CITY OF CROSSLAKE

PLANNING COMMISSION/BOARD OF ADJUSTMENT

PUBLIC HEARING NOTICE

PRELIMINARY PLAT
 OF GRAND REVIEW
 SECOND ADDITION

C2.0
SHEET

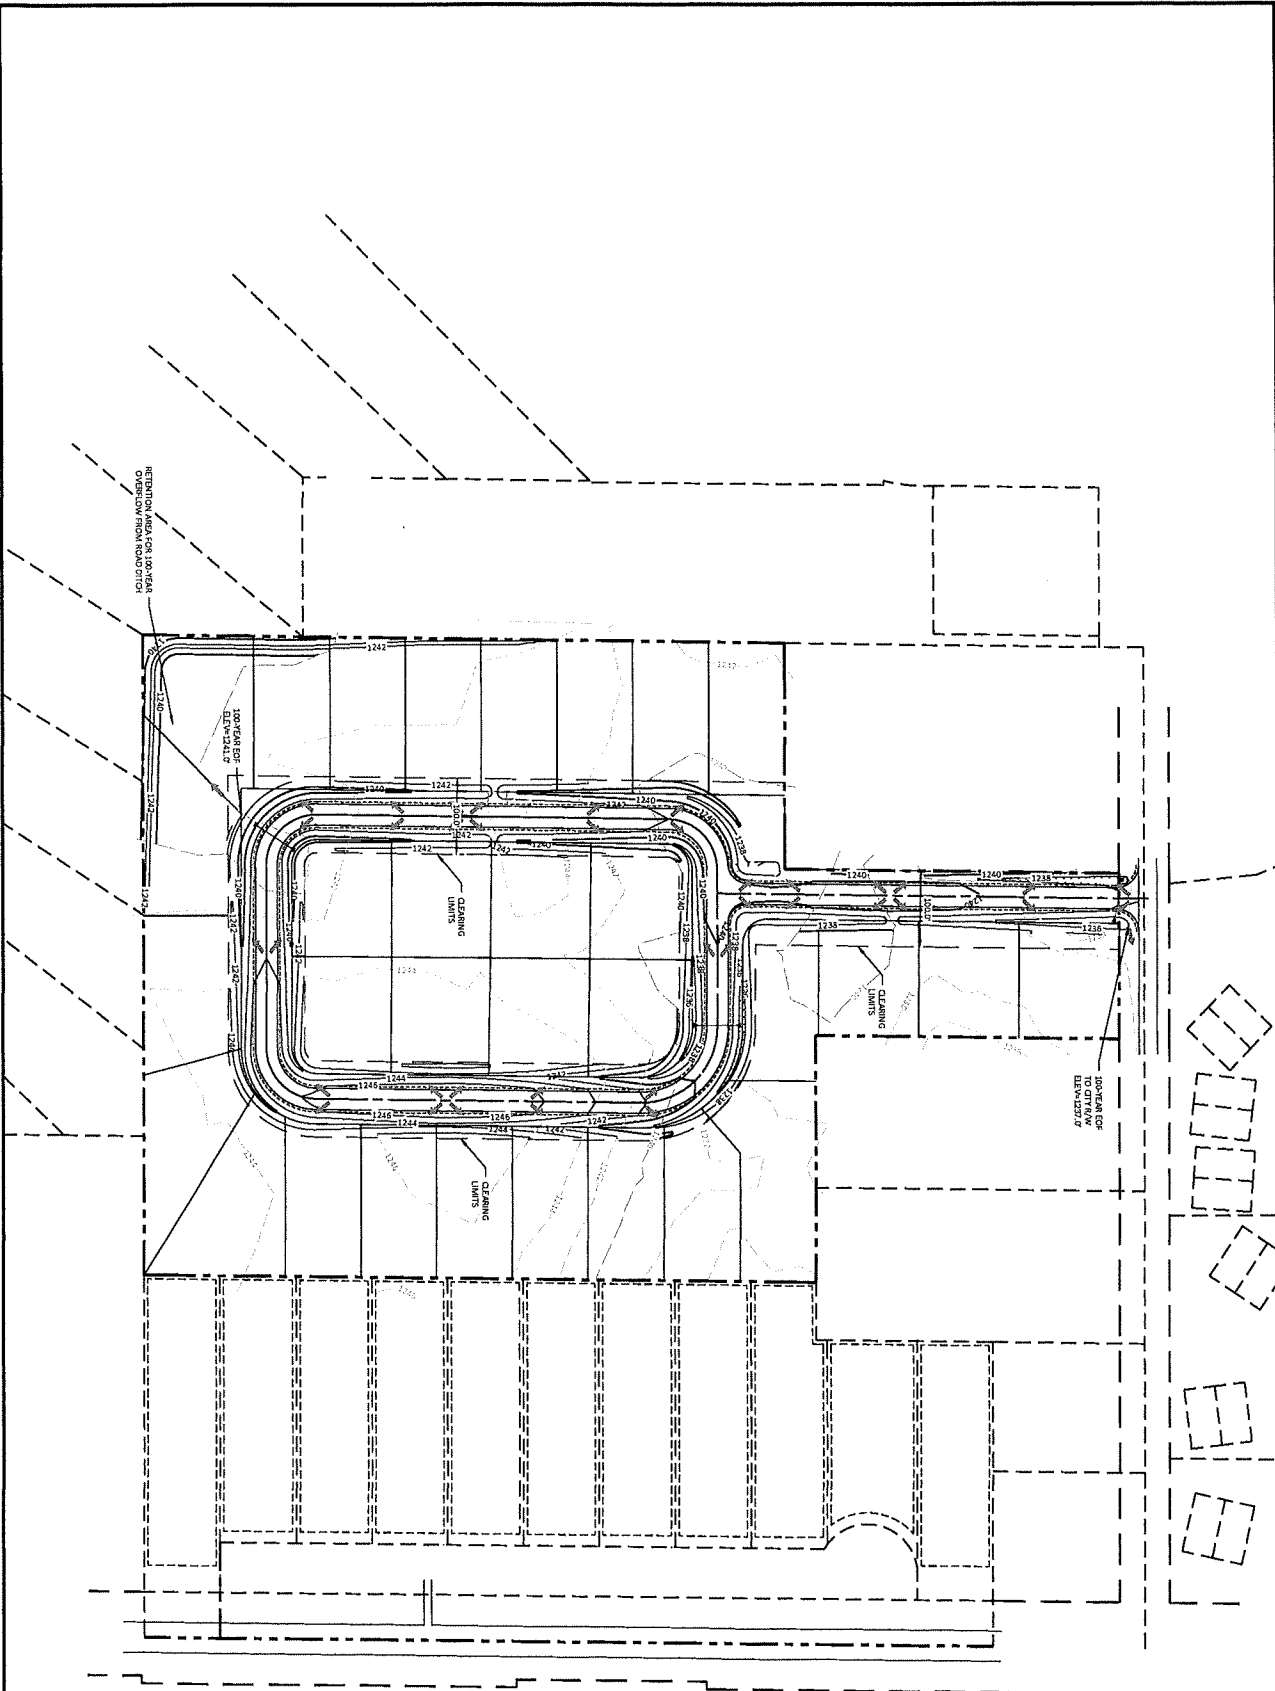
Previously we commented about runoff to adjoining properties...particularly south of the development. Your new concept it appears is to retain the 100-yr storm event within ditches with EOFs to the south of the property and near the north connection with East Shore Road. To be clear, we didn't request the full site store the 100-yr storm event but we did raise concern with stormwater discharge beyond the development property.

- Does your stormwater computations/modeling account for those platted lots that will drain to the road R/W? If not, those contributing areas should be included in your model and considered for sizing of storage and conveyance. **Each lot will have it's own stormwater management plan to accommodate stormwater runoff, so I did not include any of those lots in the calculations for the proposed road.**

An individual lot stormwater management plan would not necessarily keep stormwater from being added to the ditch storage system unless you assure that all lot stormwater is contained within the lot itself or that the lot grade is tipped away from the road. You should account for this adjacent contribution in your model so we can understand how the resulting volume works with your planned ditch storage and discharge system.

Our concern for the south area is that you have not wholly modeled the volume of runoff that contributes to the ditches relative to the storage you are providing. We need to understand the 100-yr storm impact and resulting discharge/ponding so we can understand the high-water level impacts and identify potential issues, if any.

- Is the emergency overflow elevation of 1240 ft for Ditch 7 correct on the revised drainage area sheet? Hydro CAD lists 1240.79 as the HW Elevation. We aren't sure if you are actually holding back the 100-year based on this callout or if it overflows at the EOF indicated. We'd like to see the HydroCAD model include the EOF outlet @ 1240', even if the 100-yr event doesn't utilize it. Ditch 7 does bounce to an 1240.79' as you stated above. **The overflow should be at 1241. Final grading will show that. The 100-year event is contained in Ditch 7.**

- Per city ordinance please verify that nearby existing and new buildings are/will be greater than 1 foot above the HWL of a 100-yr event passing through the drainageway adjacent. **How are you typically handling this one? Are you requiring a survey crew to go out and get a FFE on these buildings to confirm?**

From what you provided, it appears that lots 3,7,4,8,14,15,16,17 will contribute to the stormwater draining to the ditches and in big storm events to PID 14290655 unless their lot stormwater runoff is contained or directed away so it doesn't contribute.

You wrote: I've made changes to the grading and storm model per your comments. I have added some depth to the ditches to increase storage volume. We are easily containing the 100-year storm with this concept. EOF would be at the same location on the south side (as that is the natural drainage path). The other EOF would be at East Shore Road where it would overflow to the existing ditch.

- Do you intend that each lot will meet its own MPCA stormwater requirement for treating 1" over the new impervious? **Yes, each lot will have its own stormwater management plan. I believe that has been Dan's intent all along on this one.**

- Are you intending there will only be discharge at the north and south EOF locations? **Correct, the EOF for the site is at East Shore Road on the north end and down the lot line between lots 15 & 16 as was shown on the previous concept. Again, we have the volume in the ditches to contain the 100-year event, so nothing will overflow to the south until you get an event in excess of the 100-year event. This is the natural and existing drainage way on the south side of the property.**

- Where does water from D5/D4 go? Does it overflow? Is it directed to East Shore Rd? **D5/D4 will overflow to the north to D1 and ultimately East Shore Road.**

That is probably the best way of doing this. We have GIS/LiDAR contours only which aren't accurate enough. You could survey the FFE and where the overflow water is going to drain in the natural drainage way/area. Verify based on the EOF outflow that the HWL in the drainage way is 1 foot below the FFE. Based on GIS contours any overflow water will sit on the back part of lot 15 and PID 14290655 around the 1238 contour. The building on PID 14290655 looks to be between the 1240 and 1238 contour. The water will not flow off these lots but will pond at the 1238 contour. We want to make sure the buildings near this area will not be affected by the overall site runoff from the final "built out" conditions of the development for the 100-yr event.

C2.1 SHEET

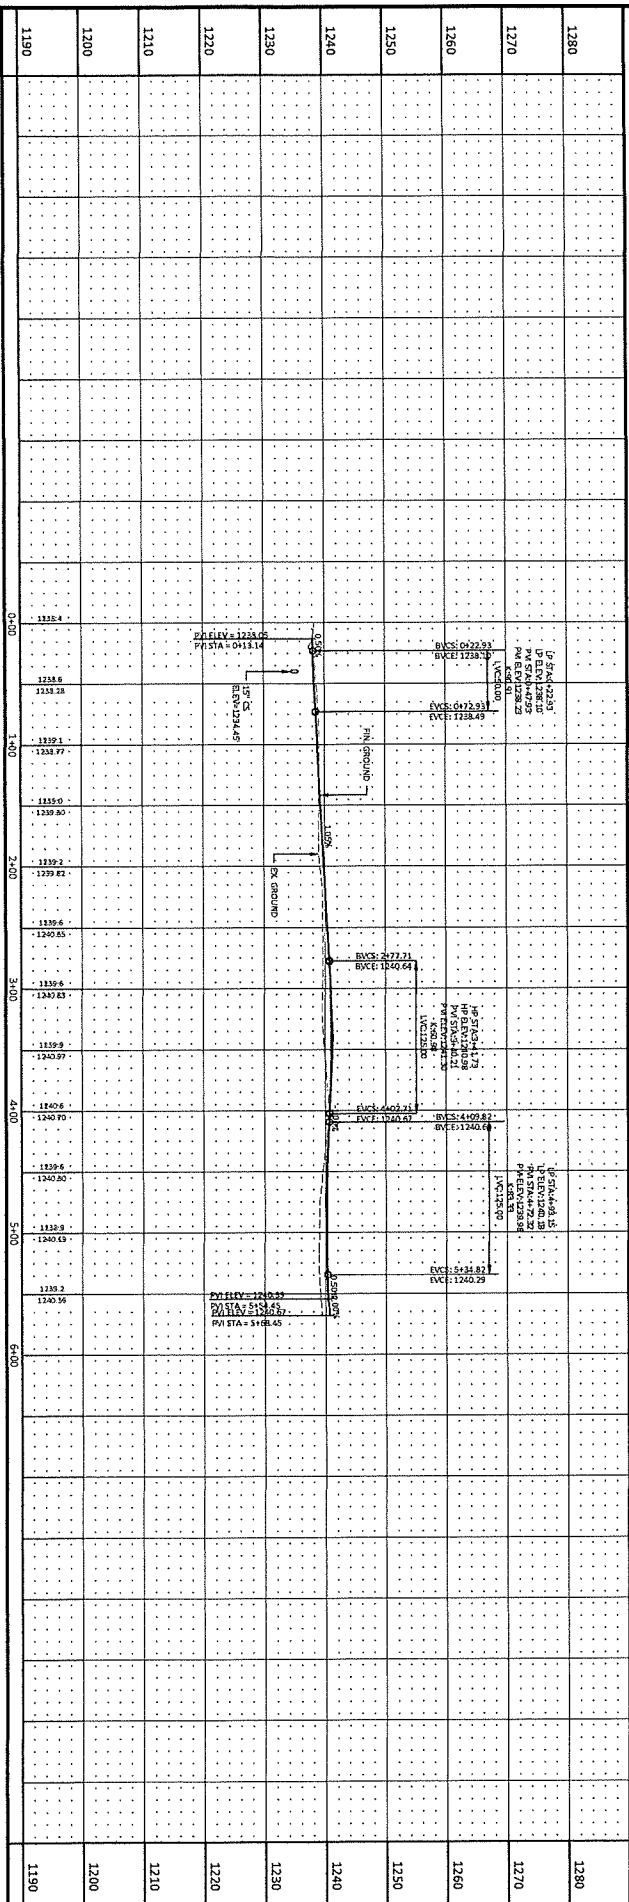
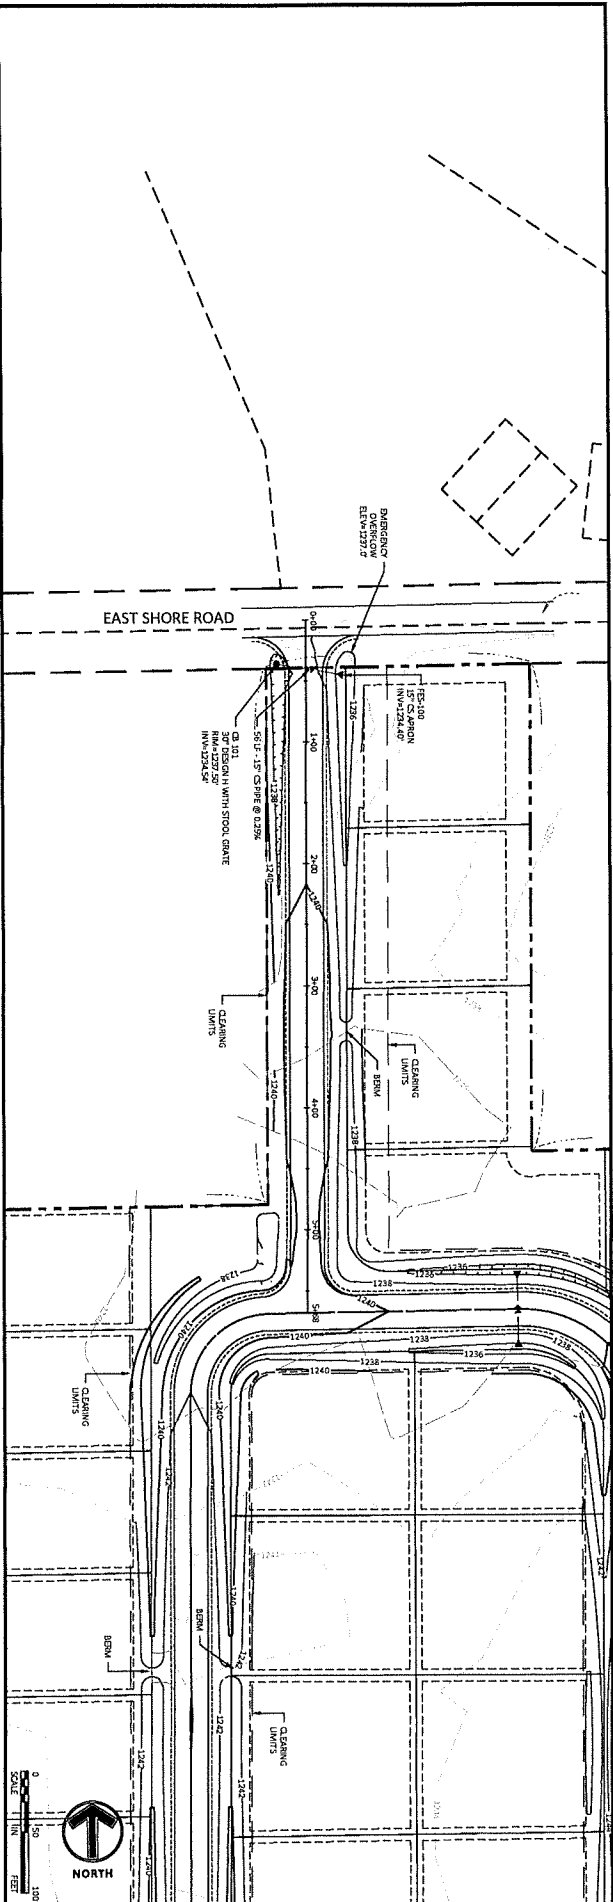
- The plans call out 12" CMP culverts. However, we understand Crosslake requires driveway culverts to be a minimum 15" diameter. Verify the use of 15" culverts and if a 2-foot deep ditch as planned provides adequate cover that does not extend into the aggregate base.

- Culverts are also shown as being installed flat...which will create a maintenance issue for the City. More depth on the ditches would give flexibility to place slope on culverts.

I still have a shallower ditch on the west side of the entrance. The grades are tight along the west side, so I did have to add a small catch basin to get cover on the 15-inch culvert at the crossing near East Shore Road.
